675 Somerville Ave. Mixed Use Housing

Development Review Application

Architectural Plans - Change Narrative

Project Name:	675 Somerville Avenue	Plan Revision:	2
Project #:	24.01	Revision Name:	ISD Comment Resolution
Drafted by:	BOS UA, LLC	Date of Issue:	6/9/2025

A2.101

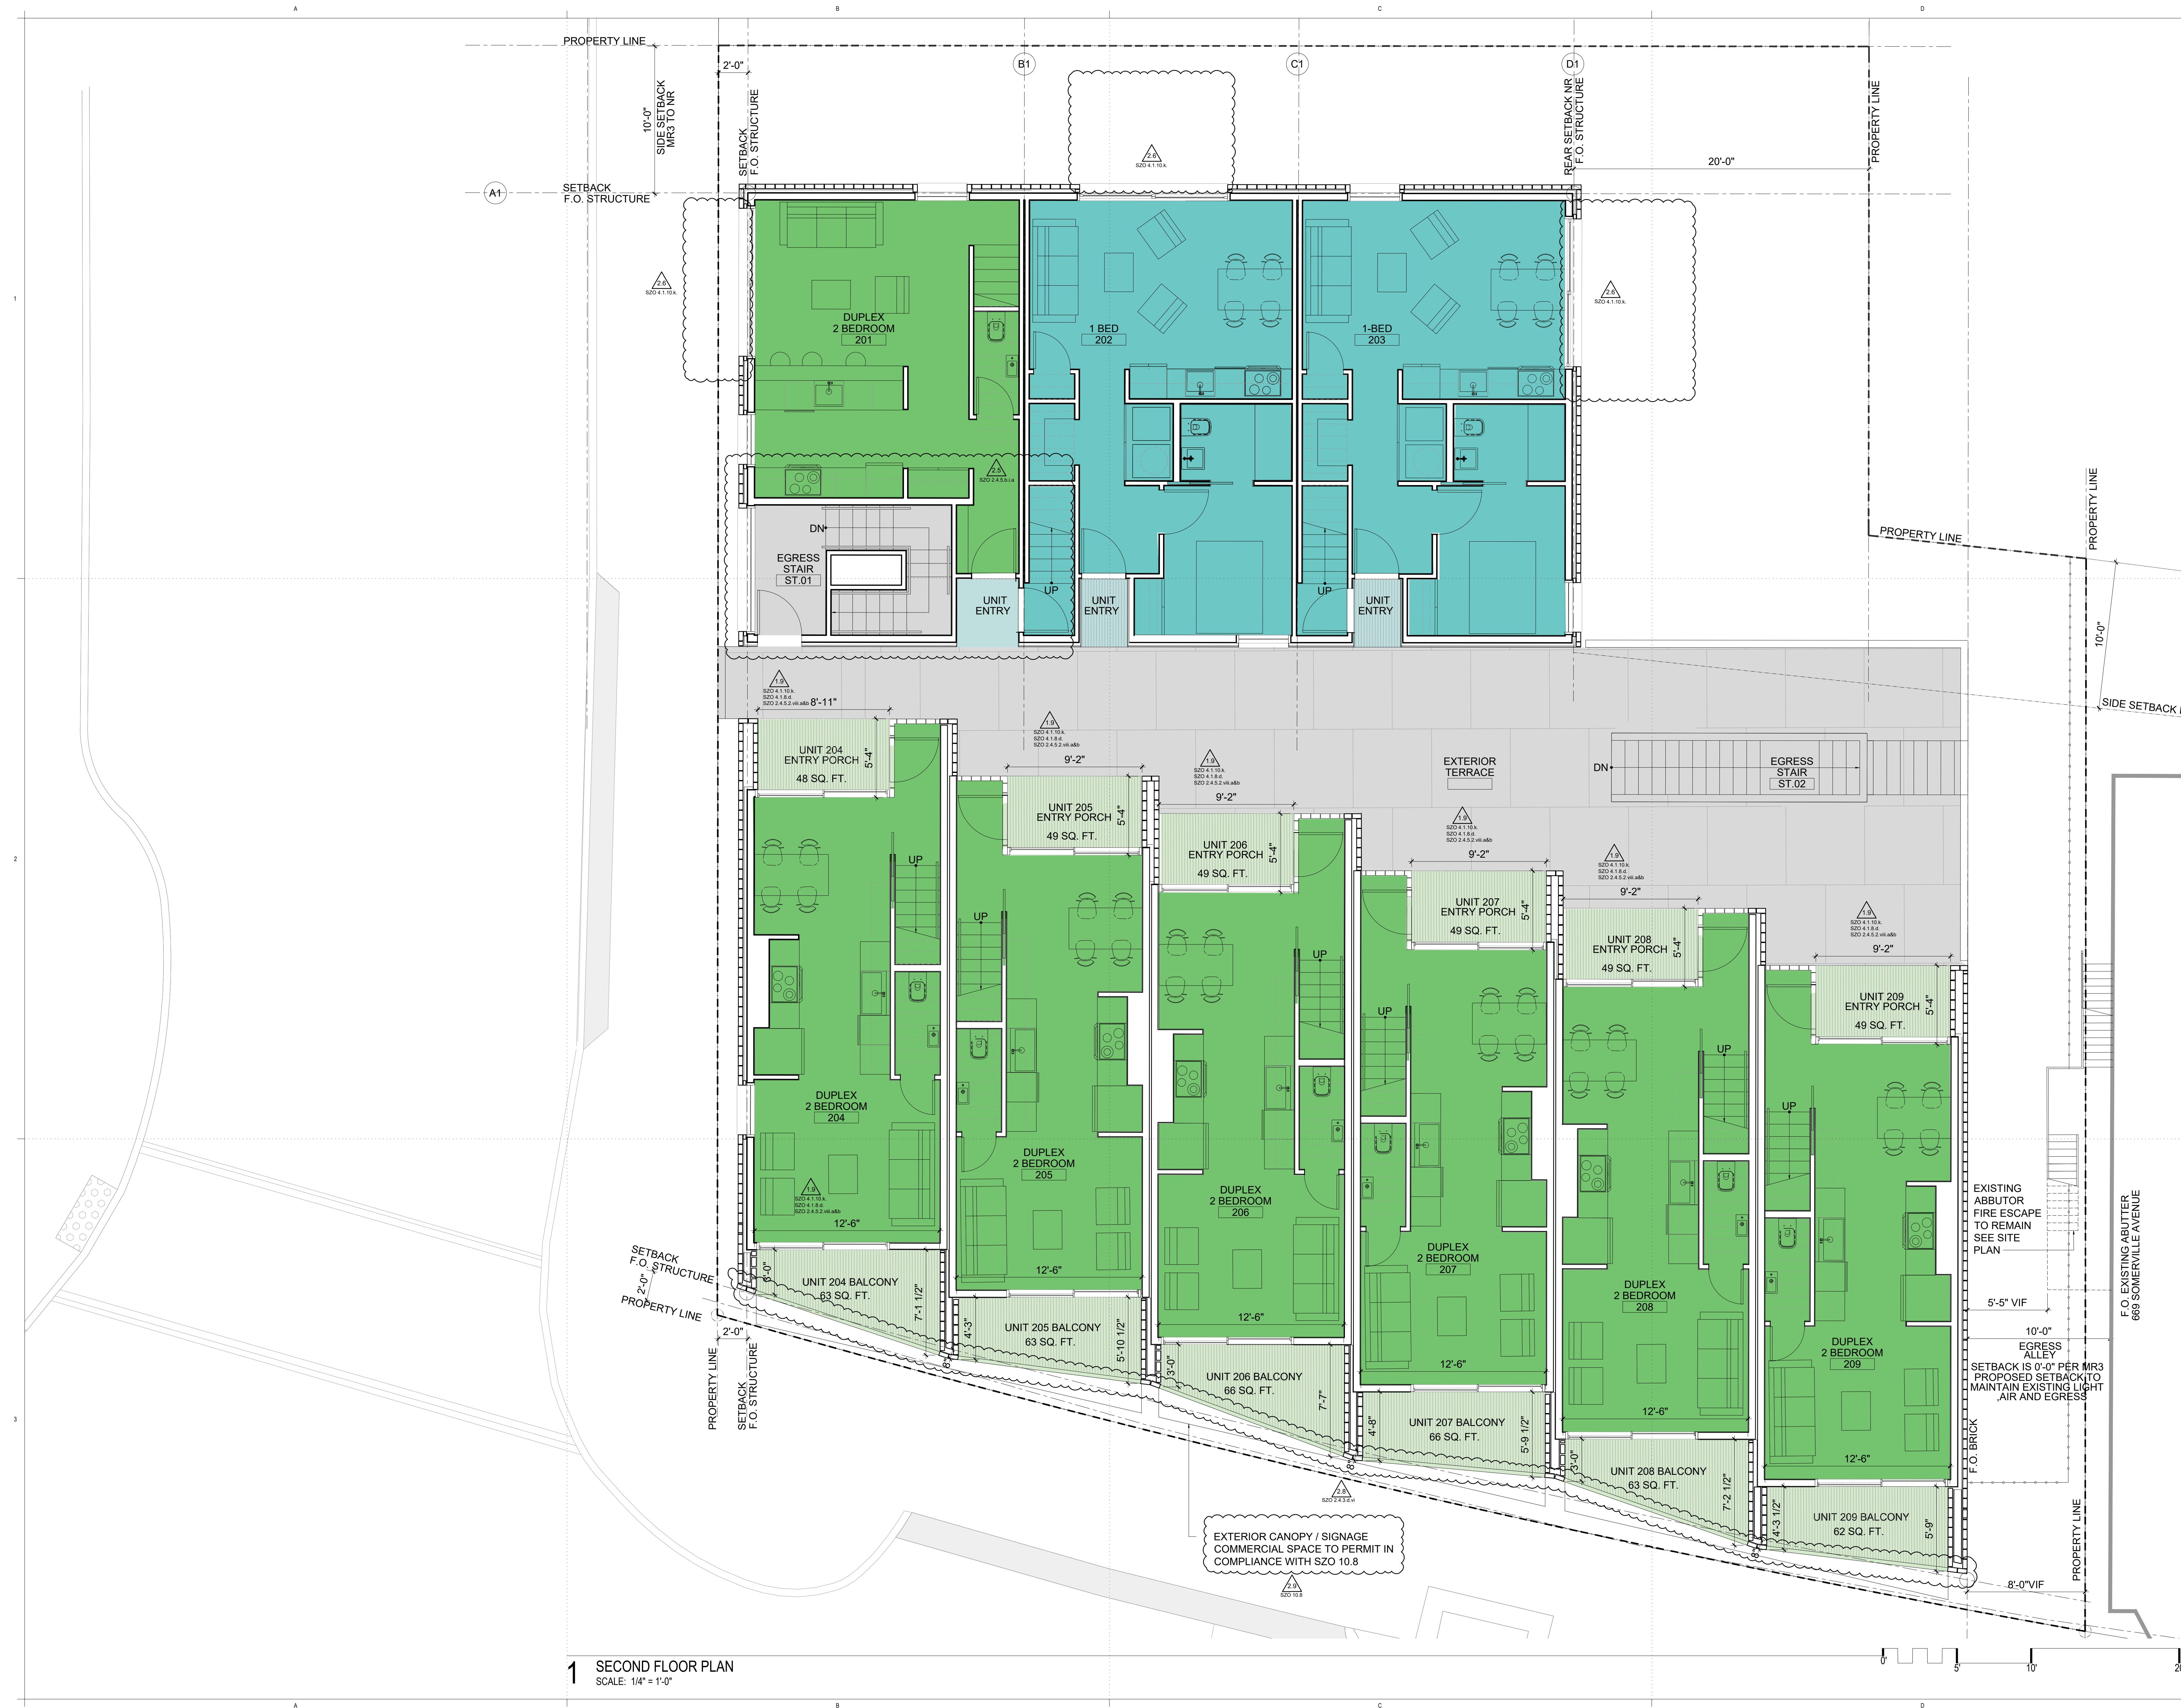
Use Group	OLD Sq. Ft.	-	New Sq. Ft	Commercial	2,732 sf		2,644 sf	Residential	11,899 sf		11,999 sf	Total GSF	14,631 sf		14,643 sf	Record
Use Group	OLD Sq. Ft.	-	New Sq. Ft																	
Commercial	2,732 sf		2,644 sf																	
Residential	11,899 sf		11,999 sf																	
Total GSF	14,631 sf		14,643 sf																	
1	A2.101	First Floor Plan	Long term bike storage moved to the southern wall of Residential Lobby to accommodate new access for Unit 103.	Record																
1.1	A2.101	First Floor Plan	Use & Occupancy – Commercial Space Depth clarified to comply with 30’ minimum of leasable space.	4.1.8.d																
1.2	A2.101	First Floor Plan	Residential lobby entry width increased to 15’ to comply with SZO.	4.1.10.g																
1.3	A2.101 A3.100 A3.101	First Floor Plan North South Elev. East West Elev.	Residential Unit 103 / 103 entry relocated so primary access is off residential lobby / primary front. Removed primary access from the side yard.	2.4.5.b.i.a																
1.4	A2.101	First Floor Plan	Added dimensions and square footage of private yards for ground level units. Units 101, 102 and 103 each have been provided with 50sf of private outdoor amenity space directly accessed by a sliding glass door.	4.1.8.d. 2.4.5.2.viii.a 2.4.5.2.viii.b																
1.5	A2.101	First Floor Plan	Communal outdoor amenity space dimensions and area provided to clarify shared outdoor amenity space to be distributed amongst all 14 units. Approximately 40 SF per unit provided at ground level in addition to private amenity spaces outlined.	2.4.5.2.viii.c																
1.6	A2.101	First Floor Plan	Single commercial space is now being proposed.

#	Sheet	Name	Description	SZO Reference																
1.7	A2.101	First Floor Plan	Added 12' curb setback line with dimension to demonstrate compliance.	4.1.8.a/b																
1.8	A2.101	First Floor Plan	Gate moved forward toward Somerville Avenue to respond to UDC comment to limit acces to the ally and respond to abutter comments to restrict this egress alley becoming a parking space.																	
1.9	A2.102 A2.103	Second Floor Plan Third Floor Plan	Added dimensions and square footage of private balconies for upper level units. All units meet or exceed 24sf of clear area for outdoor amenity space In addition, per SZO 2.4.5.2viii.c, 40SF of area attributed to each unit with the common shared outdoor amenity space on the ground level. See A2.101.	4.1.10.k. 2.4.5.2.viii.a 2.4.5.2.viii.b 2.4.5.2.viii.c																
1.10	A2.102 A2.103	Second Floor Plan Third Floor Plan	Clarification of architectural feature providing vertical continuity from floor to floor, to integrate the balconies into the main front façade.	2.4.3.d.ii																
1.11	A2.103	Third Floor Plan	Revised line of structure to be within the 2'-0" setback per SZO.	2.4.3.d.ii																
2.1	A0.006	Gross Floor Area Calculations	Revised gross square footage numbers to reflect plan changes that resulted from updated sidewalk compliance

#	Sheet	Name	Description	SZO Reference
2.6	A2.101 A2.102	First Floor Plan Second Floor Plan	Removed 2nd floor Balconies for units 202 and 203, and the 3rd floor balconies for units 201, 301, and 302 that were encroaching into the rear and side setbacks. Communal outdoor amenity space provides required outdoor space per unit.	4.1.10.k

2.7	A2.101	First Floor Plan	12 ft sidewalk width is now being met. The exterior wall along Craigie Street moved so that it is 12' clear.	4.1.16.a.i
2.8	A2.101 A2.102	First Floor Plan Second Floor Plan	Massing projections on the Somerville Ave facade were revised so that the walls portions of the façade do not encroach on the front setback. Insulated sheathing and exterior wall finish do encroach up to the 8" maximum, as allowed so per SZO 2.4.3.d.vi	2.4.3.d.vi

2.9	A2.101 A2.102	First Floor Plan Second Floor Plan	Any proposed signage will need to adhere to the requirements from SZO 10.8.	10.8
2.10	A0.007 A3.100	Fenestration Calculations North South Elevations	Added new sheet A0.007 to graphically support fenestration calculations and façade adjustments required. Adjustments to fenestration percentage updated so that calculations independently for each story on each façade are in compliance with SZO.	2.4.5.a.i.a
